SERVICE BULLETIN

OCTOBER 23 1997

PRODUCT UPDATE: FUEL TANK, HEAT SHIELD

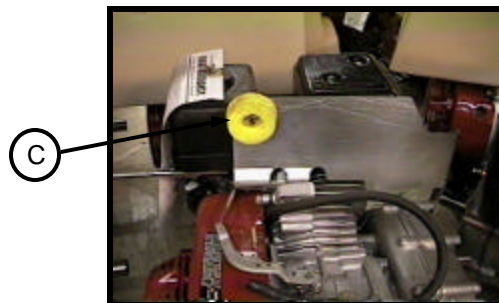
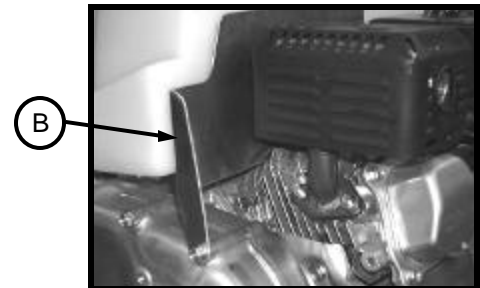
The fuel tank area at rear of muffler becomes soft and/or develops a leak.

The muffler deflector may restrict exhaust flow from muffler causing excess heat which can distort fuel tank and in extreme cases contact muffler. If this should occur, fuel tank can become soft and could result in a rupture [A].

Install Heat Shield immediately [B].

Fuel Tank, Heat Shield: **Part#00111**

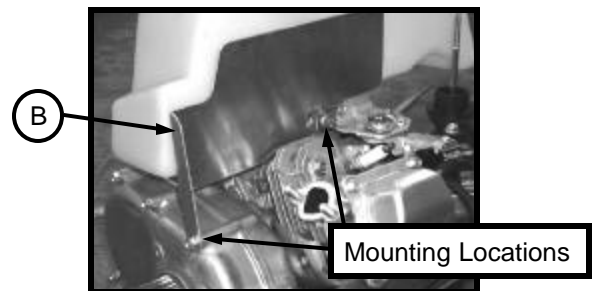
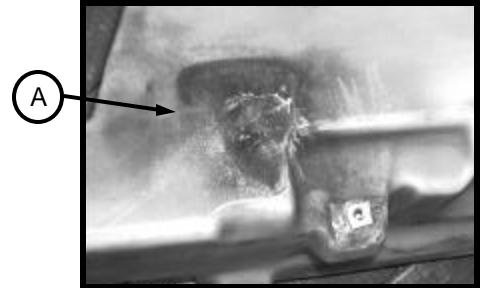
Muffler guard cracking from engine vibration.

Install Flat Bushing Part# 009071 Qty [1] immediately [C].

00877 - Bolt, 1/4-20x1 Qty[1]

00948 - Nut, 1/4-20 z Qty [1]

00966 - Washer, 1/4-z Flat Qty [1]
